PRIVATE PLAN CHANGE 94
ADDENDUM HEARING REPORT
WAIRAKA PRECINCT IN CARRINGTON ROAD,
MT ALBERT
MINISTRY OF HOUSING AND URBAN
DEVELOPMENT – HANNAH MCGREGOR

Addendum Section 42A Hearing Report for Proposed Private Plan Change 94: Wairaka Precinct to the Auckland Unitary Plan (Operative in part)

Height Area 1

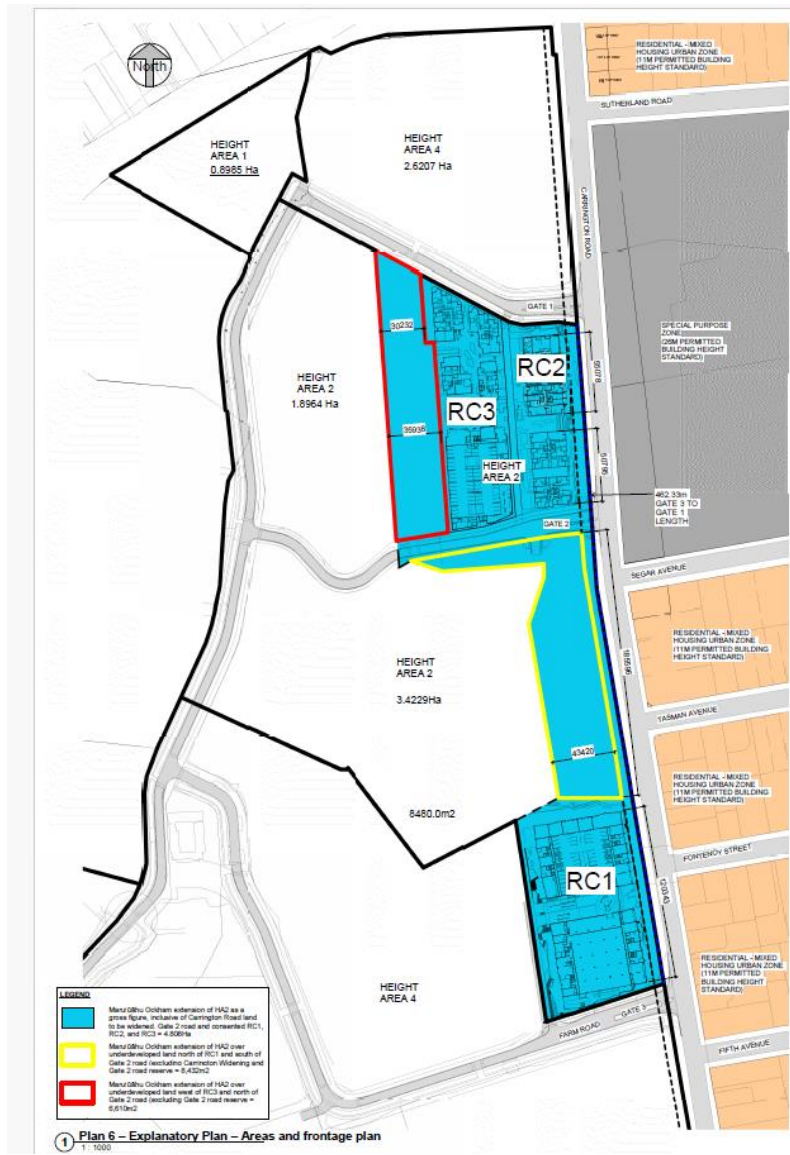
15. While the Applicant through their evidence has modified the proposed controls – the lower tower being required to be closest to the Oakley Main Hospital building - the Height Area 1 issues remain unresolved. The primary s42A report assessments should be referred to in that respect. Briefly, the tower heights proposed are not required to give effect to the NPS-UD – are not in a location that the NPS-UD, or the RPS, seek for the highest degree (height) of intensification. There are also effects, in particular landscape effects, that (relying on Mr Brown's evidence) cannot be mitigated. Mr Brown in his Addendum Review, adds adverse effects on views to a natural landmark - Maungawhau / Mt Eden – to his previously stated concerns. Mr Ray maintains the concerns he expressed in his primary memorandum, noting that some of these could be mitigated through extra design control.

16. Put simply, the s42A recommendations remain that Height Area 1 should be deleted – then becoming part of Height Area 2 (35m maximum). This is as shown on the revised Precinct Plan 3 in Appendix A. All references to provisions relating to Height Area 1 are also removed.

Wairaka: Precinct Plan 1 (Option 1 – Recommended)

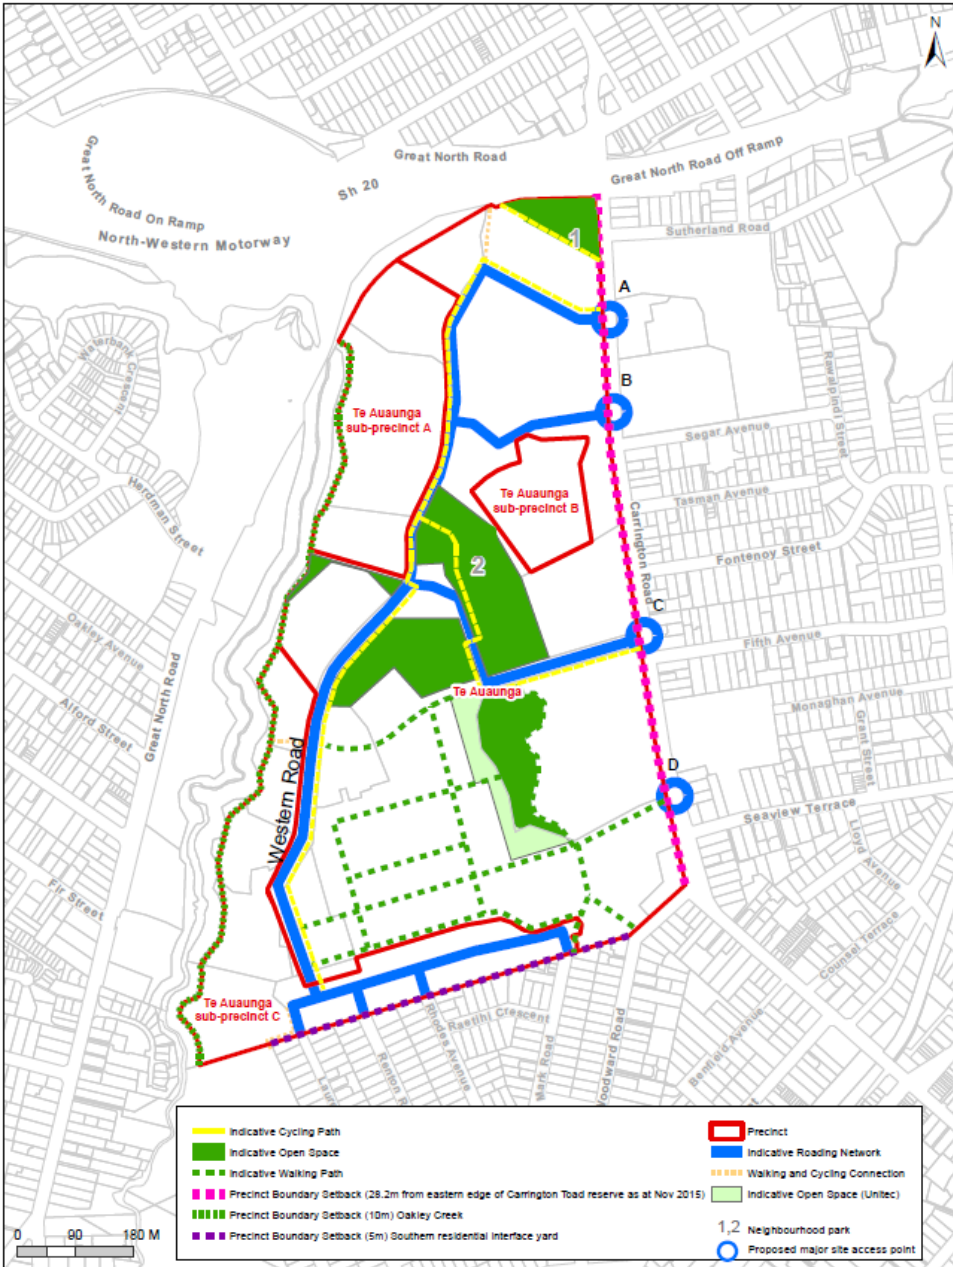
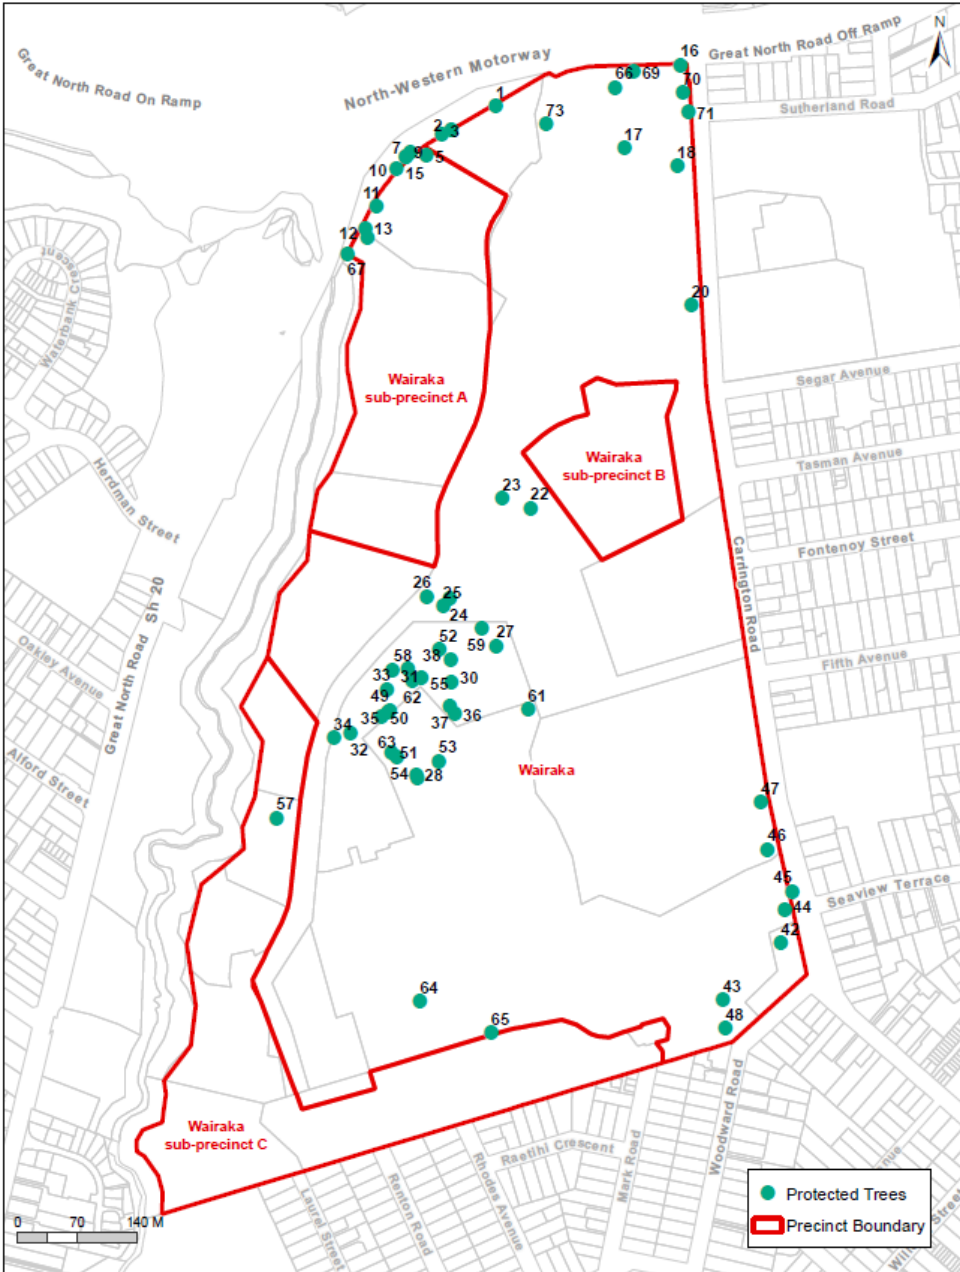
44. Option 2 (zoning open space land) would provide greater certainty and in principle that is not an option I oppose. I assess it in the s32AA table below and consider it may have merit. I note that Precinct Plan 1 identifies areas of open space, rather than zoning them. In the Open Space JWS, and in her Addendum Review, Dr Tafaroji has indicated she is not opposed to a greater area of open space being shown on Precinct Plan 1, including as proposed by Ms Barrett. That is shown on an Option 2 Precinct Plan 1 in Appendix A. In my view that option, and any zoning option, would need to be associated with more certainty as to how those areas would be owned and managed.

45. In respect of the recommended Option 1 Precinct Plan 1 I note the legend has been amended so that the identification of open space areas is "indicative". That is a signal that the areas are not necessarily in their final location and / or shape. These are matters that would be assessed at later consenting stages, including the normal process of discussion with Council (and the Local Board) about acquisition / vesting.

Wairaka: Precinct Plan 2 – Protected Trees

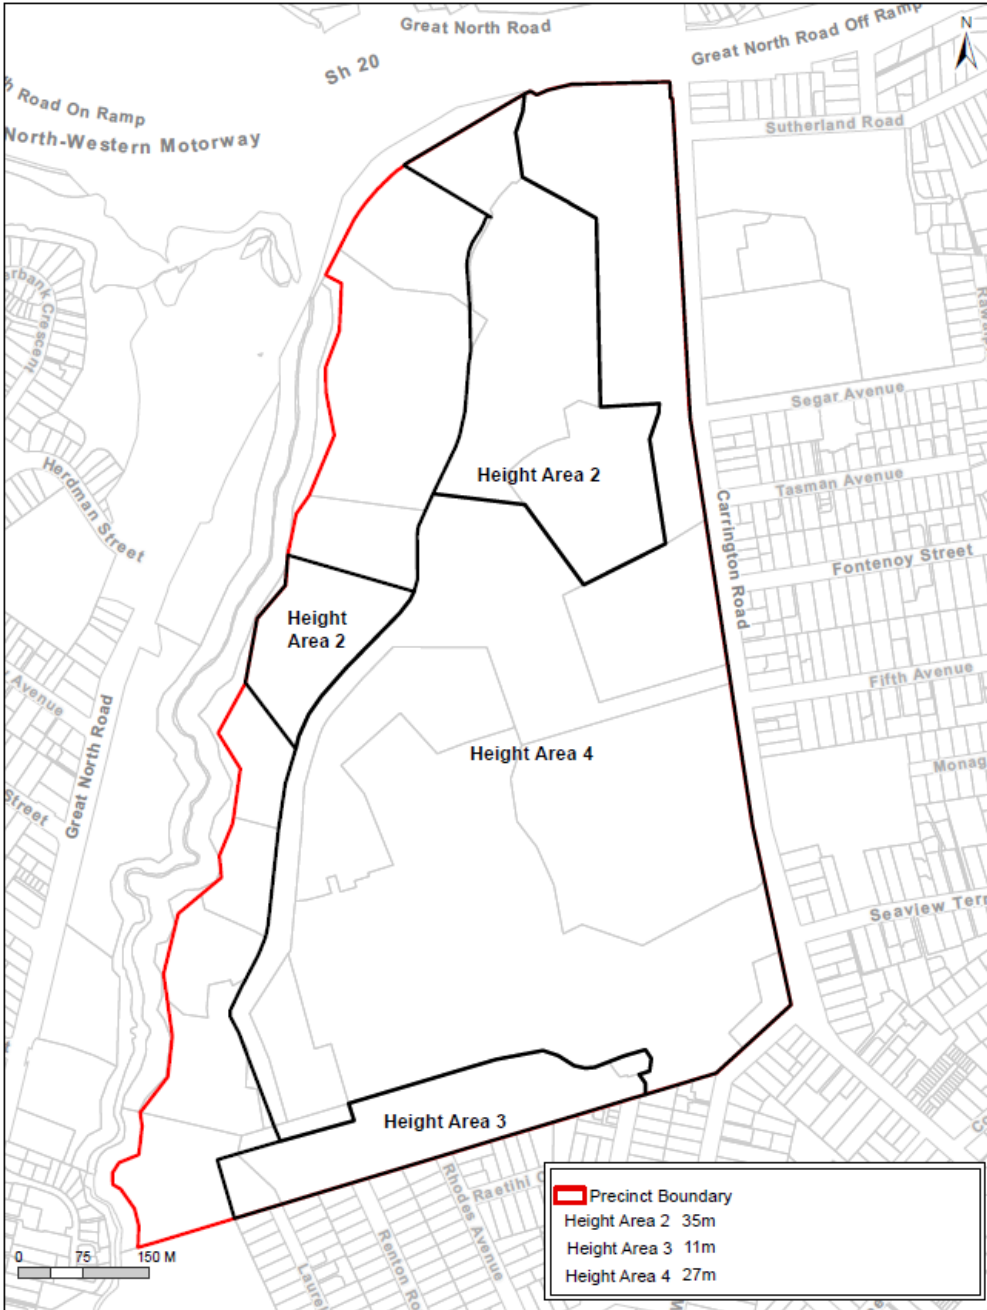
These trees are not overly significant and species wise are well represented in the area. If these are the only trees the applicant is concerned with then I can agree to have these removed from the plan.

That being said as the applicant has not raised any concerns over any additional trees I would expect that no further tree removals would be required and that there is no objection to the other recommended trees being included in the Precinct Plan.

33. On this basis I have removed trees numbered 56, 60, 68 and 72 from the recommendations. This is reflected in an amended table and Precinct Plan 2 in Appendix A.

Wairaka: Precinct Plan 3 –Additional Height

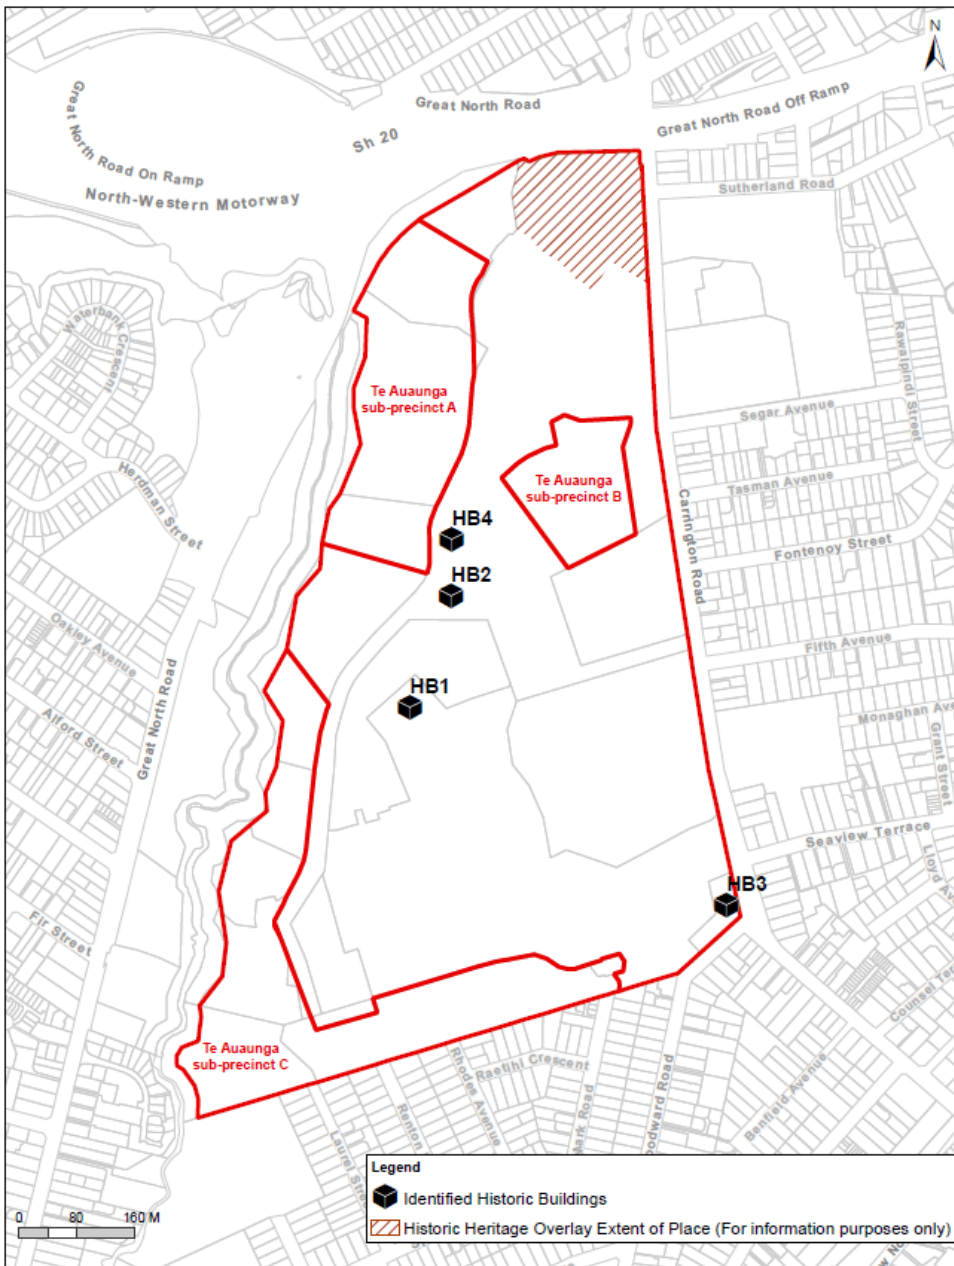
22. The changes sought are not supported by Mr Ray (urban design) or Mr Brown (landscape), apart from the area bordered in red in the plan below.

23. The area bordered in red is located between the approved development RC3, which exceeds 27m in height, and the notified Building Height 2 area. I agree that it is appropriate for this relatively narrow area of land to be relocated into the Building Height 2 area. This area is located within the precinct, i.e. away from precinct boundaries. As confirmed in the Heritage JWS, this change is not opposed by the heritage experts.
24. This amendment has been incorporated into the revised Additional Height Precinct Plan 3 in Appendix A.

Motorway Viewpoint 1 From Near The End of Rosebank Road – Present-day View:

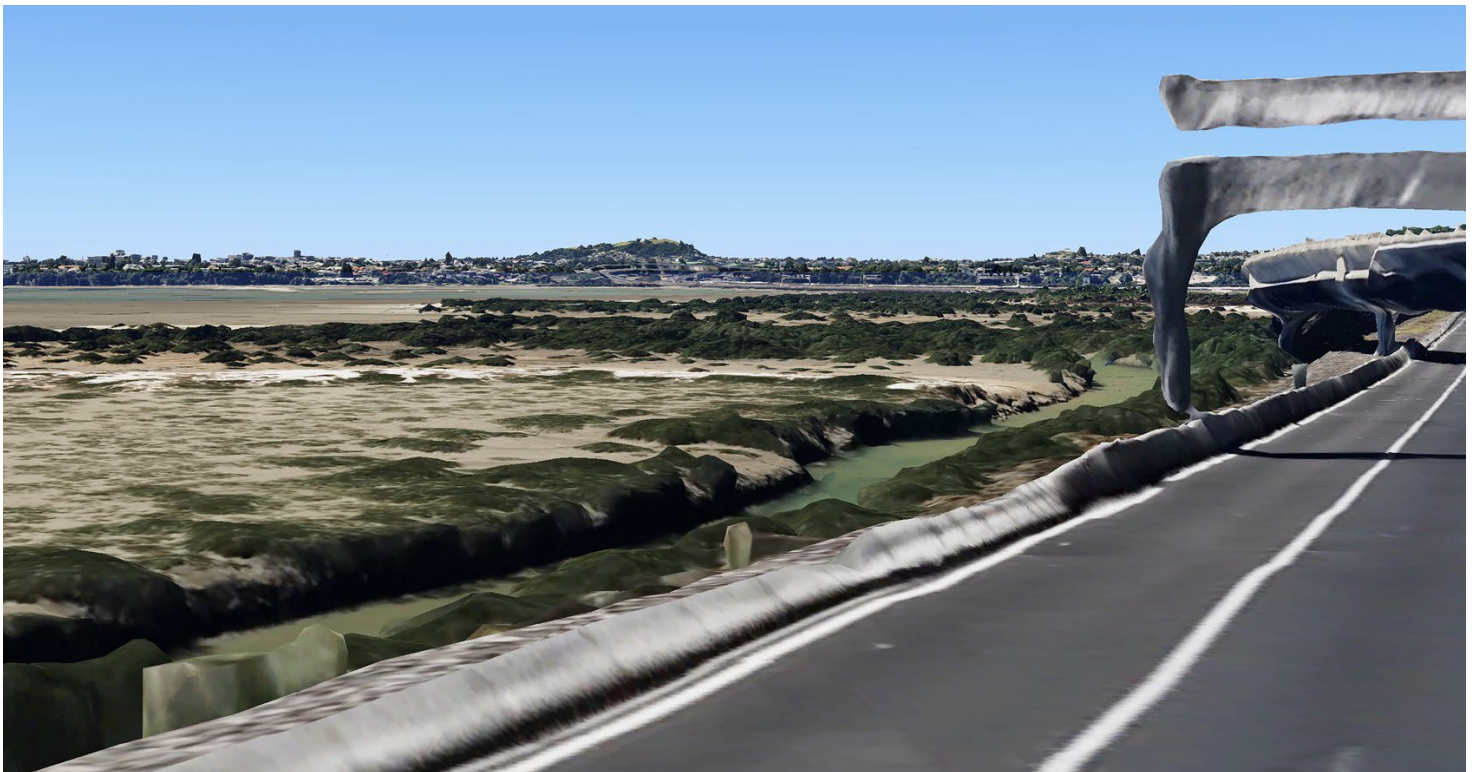
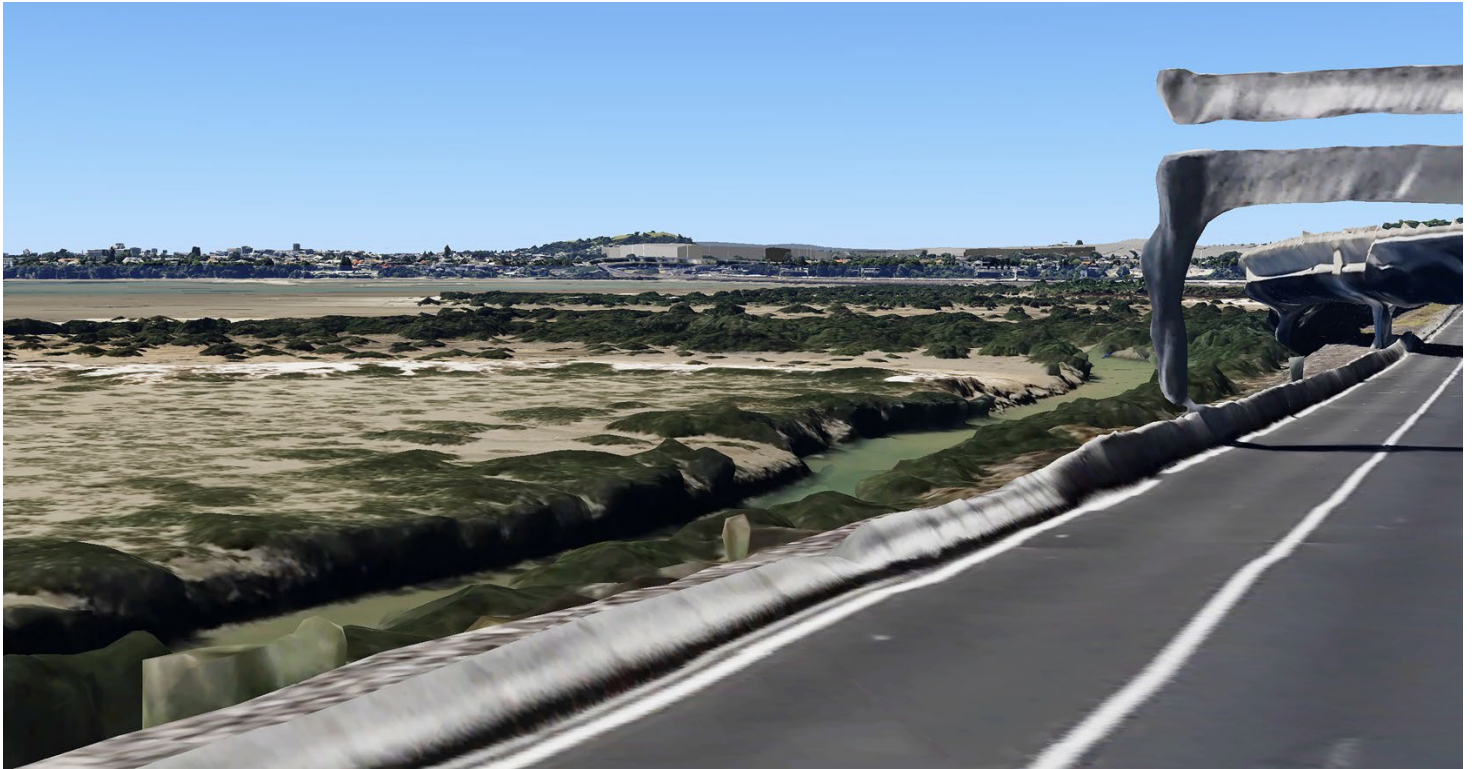
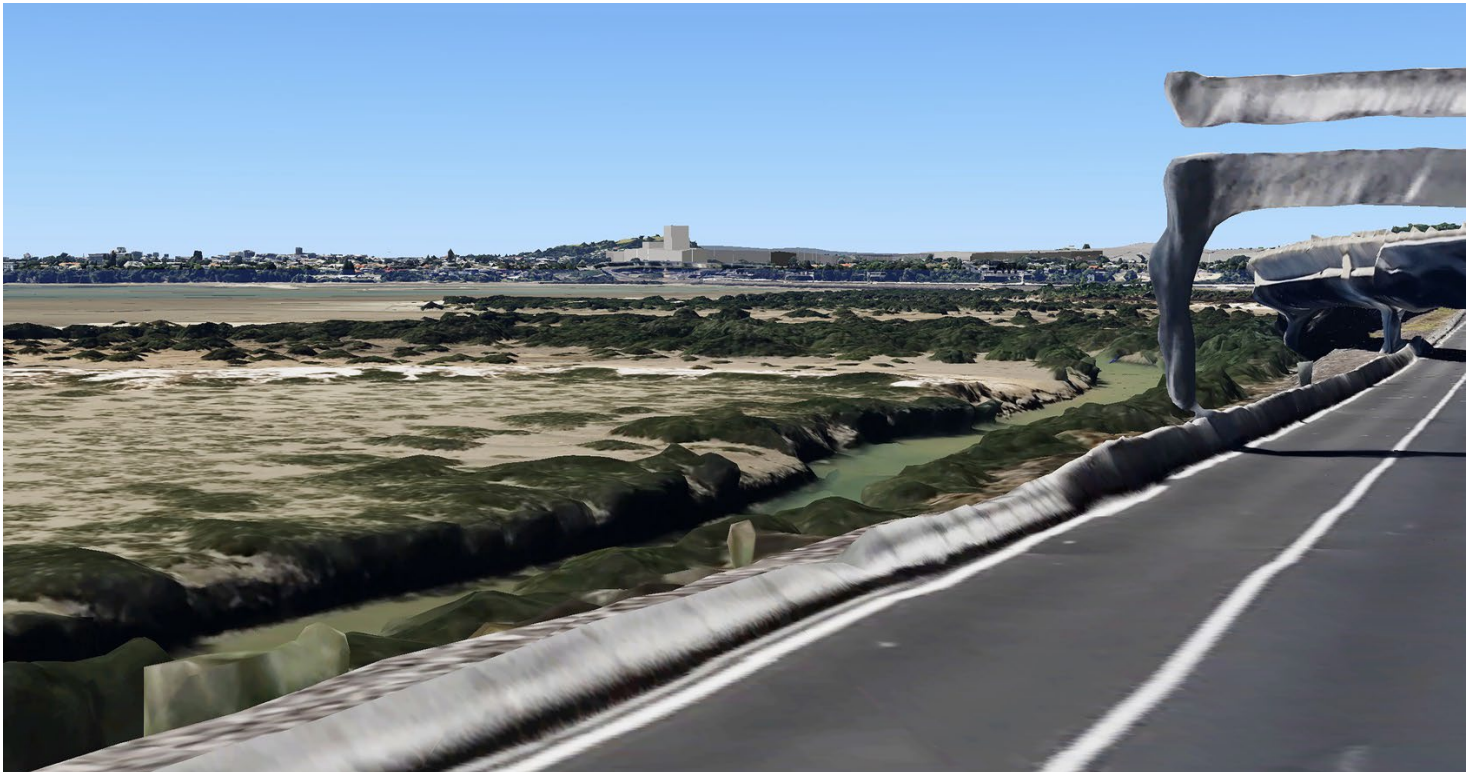
5. The first of these is the interface with the remaining MHU development north of Fifth Avenue, as is discussed at pages 8-11 of my review report. Although much of this area would face towards the Ockham / Marutūāhu development proposals shown in Ms de Lambert’s Figure 19, the general disparity in built forms between one side of the road and the other could still be significant in my view.
